APPEAL SUMMARY

Appeal ID: 23806	Project Address: 7000 NE Airport Way
Hearing Date: 6/10/20	Appellant Name: Tom Jaleski
Case No.: B-014	Appellant Phone: 9712385266
Appeal Type: Building	Plans Examiner/Inspector: David Bartley
Project Type: commercial	Stories: 1 Occupancy: A-3 Construction Type: I-A
Building/Business Name: PDX Airport	Fire Sprinklers: Yes - Throughout
Appeal Involves: Erection of a new structure	LUR or Permit Application No.:
Plan Submitted Option: pdf [File 1] [File 2]	Proposed use: Airport concourse

APPEAL INFORMATION SHEET

NORTH BYPASS SECTION

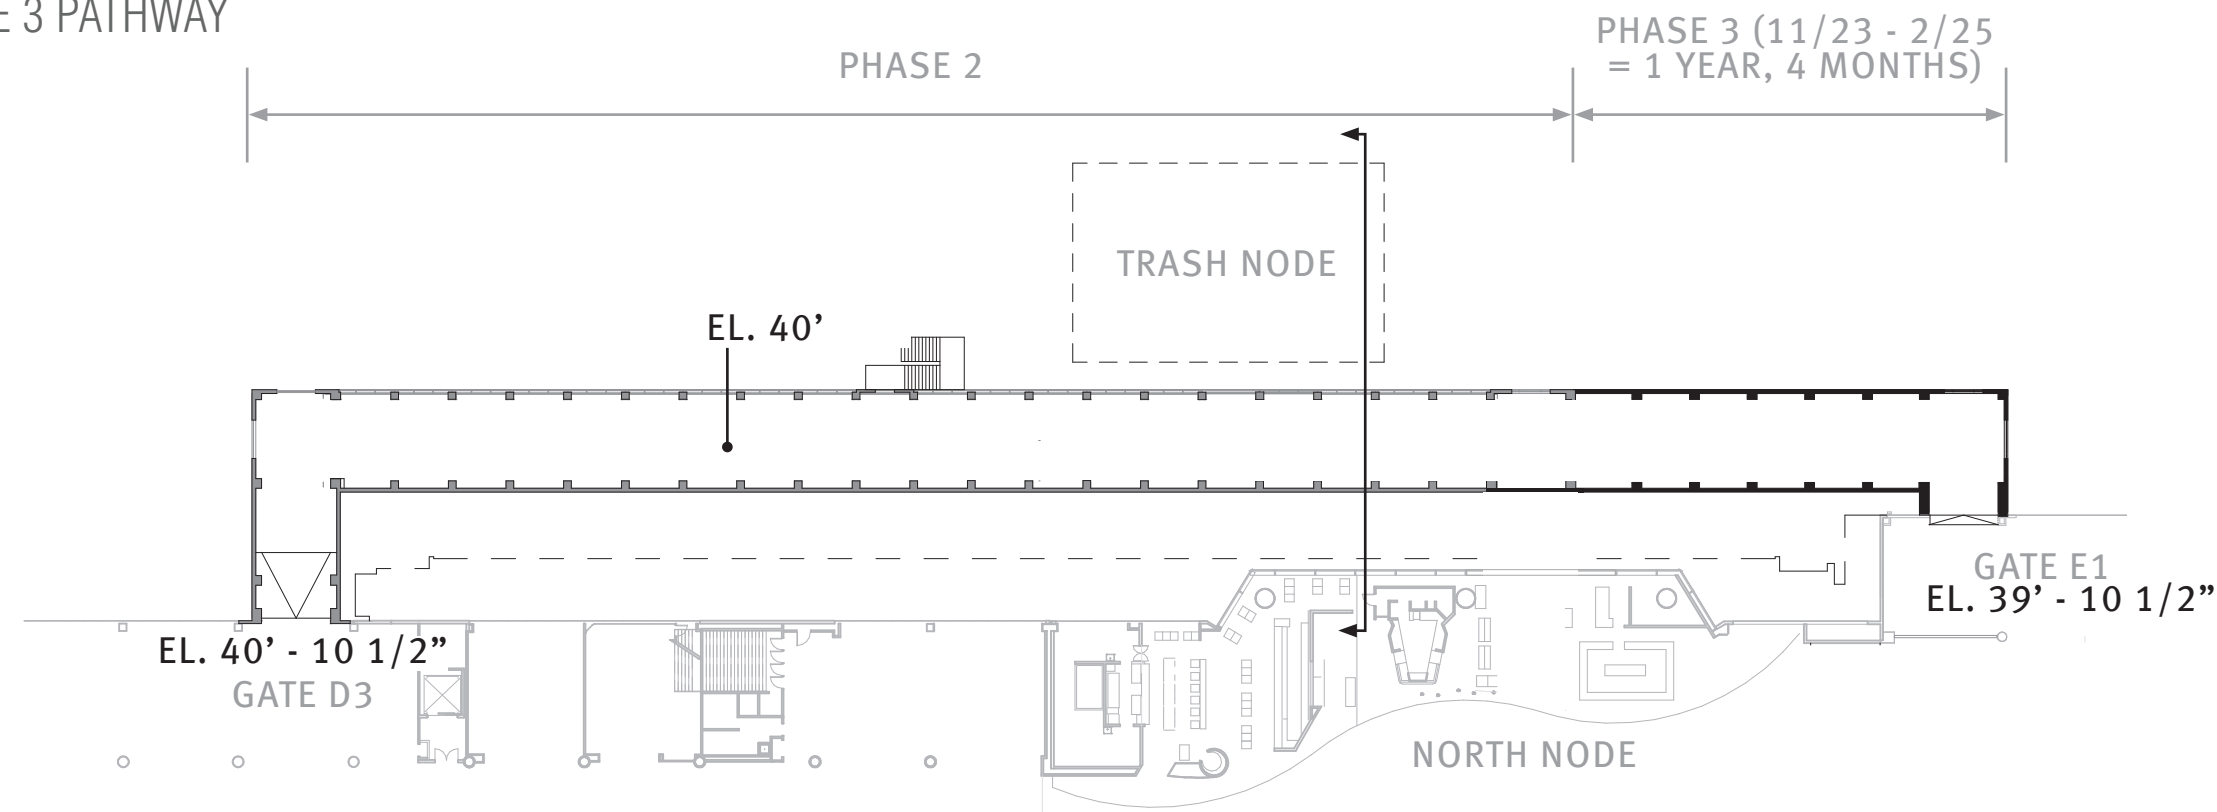
The proposed design is for the exterior walls of the bypass structures to be non-rated, including the surface of the façade adjacent to, but above, the trash structure based on fire separation distance of the bypass on the enplaning level and the trash enclosure on the deplaning level.

In this situation, the exterior walls of the bypasses and trash structures are 17'-0" or more away from each other, and offset by one story. There is minimal surface area where efficient heat transfer can take place – there is 5'-7" (diagram A) or 4'-11" (diagram B) vertically where the bottom of the bypass overlaps the top of the trash structure vertically, and the majority of that is between the vertical face of the bypass façade and the low-slope roof of the trash structure. The potential for horizontal heat transfer is negligible.

2a. Omission of fire rating at exterior walls of temporary North bypass structure: Granted provided the openings adjacent to the trash enclosure are protected on the interior side with additional sprinkler heads installed per NFPA 13 on a separate permit through the Fire Marshal's office.

Diagram B

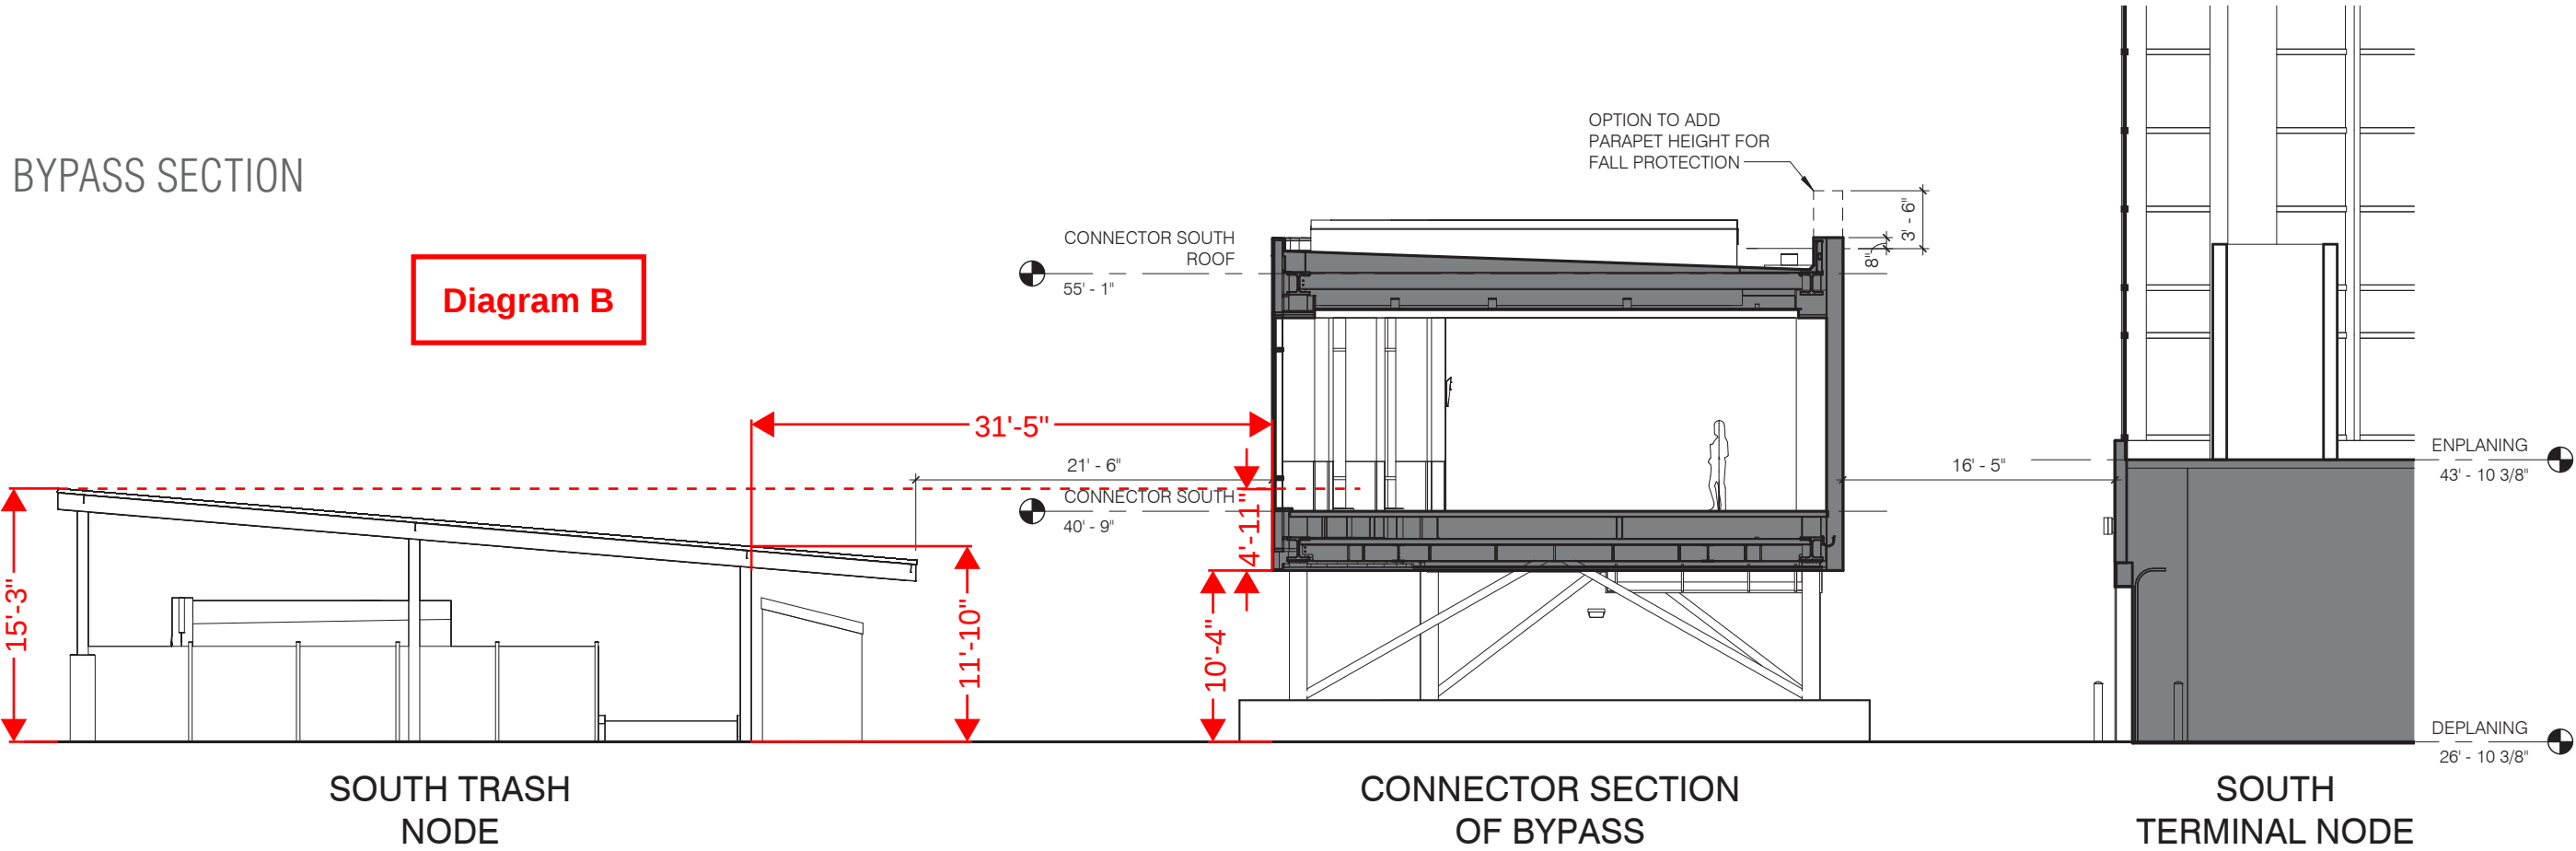
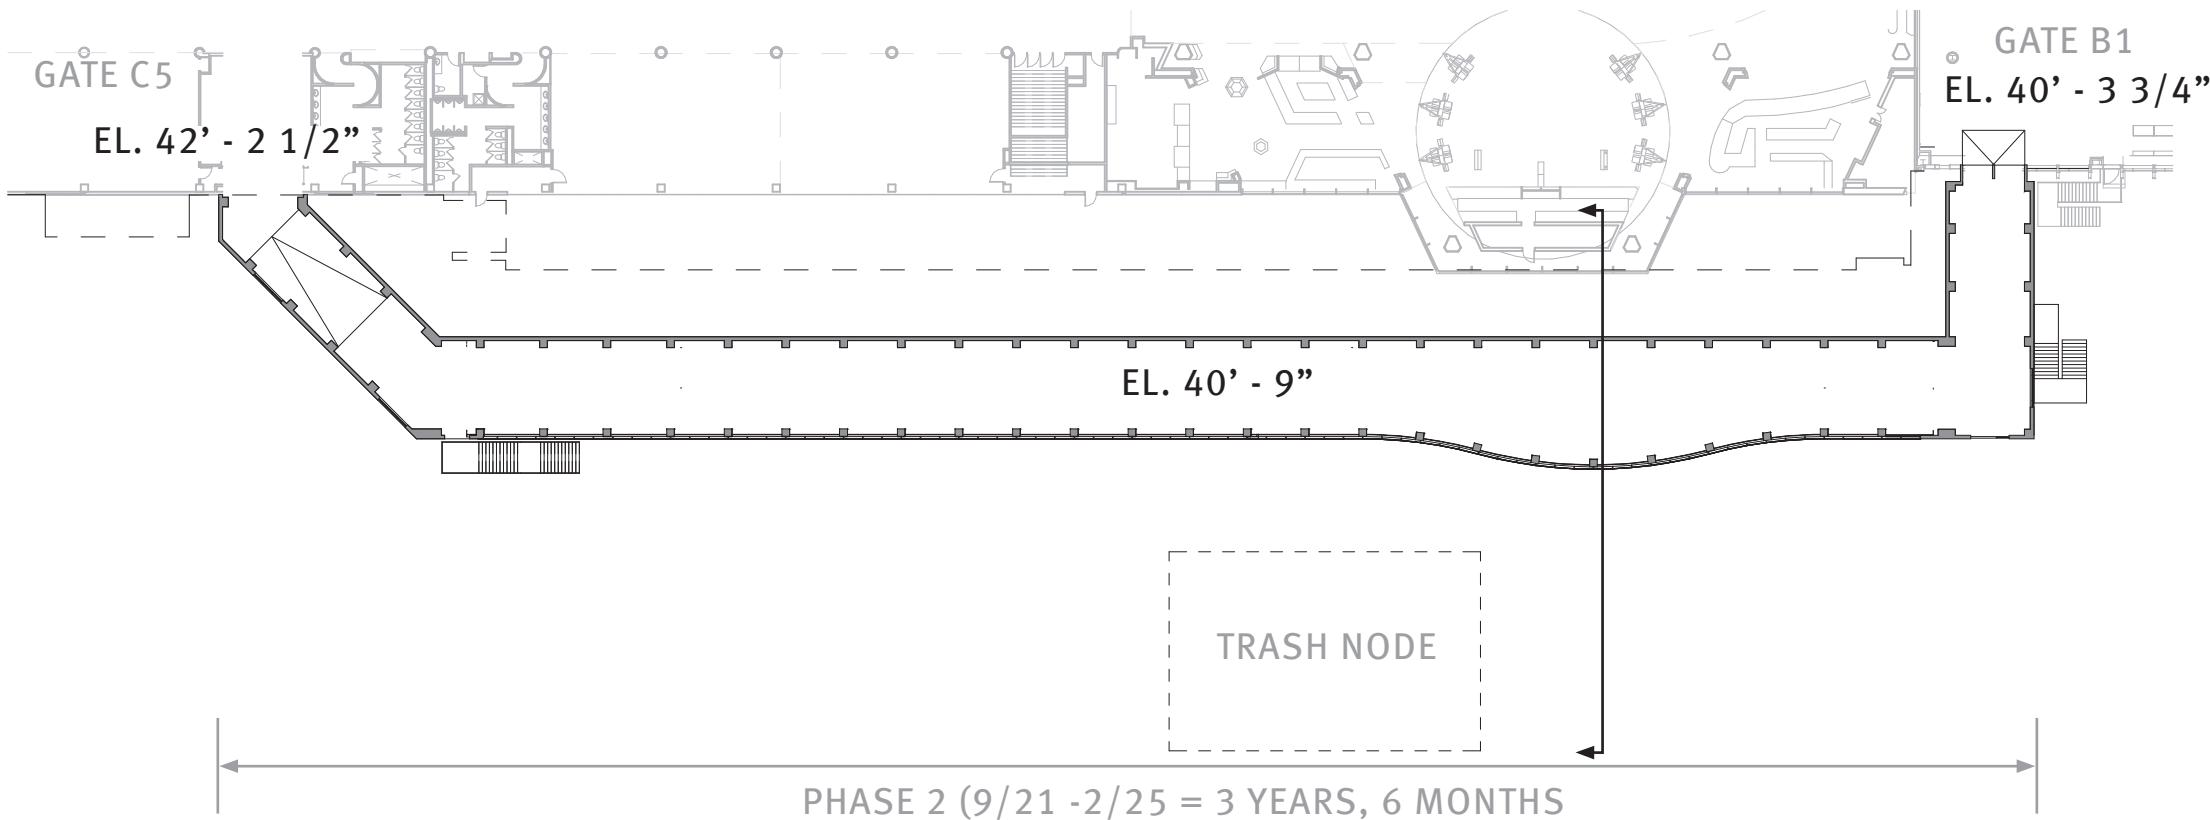
2b. Omission of fire rating at exterior walls of temporary South bypass structure: Granted as proposed.
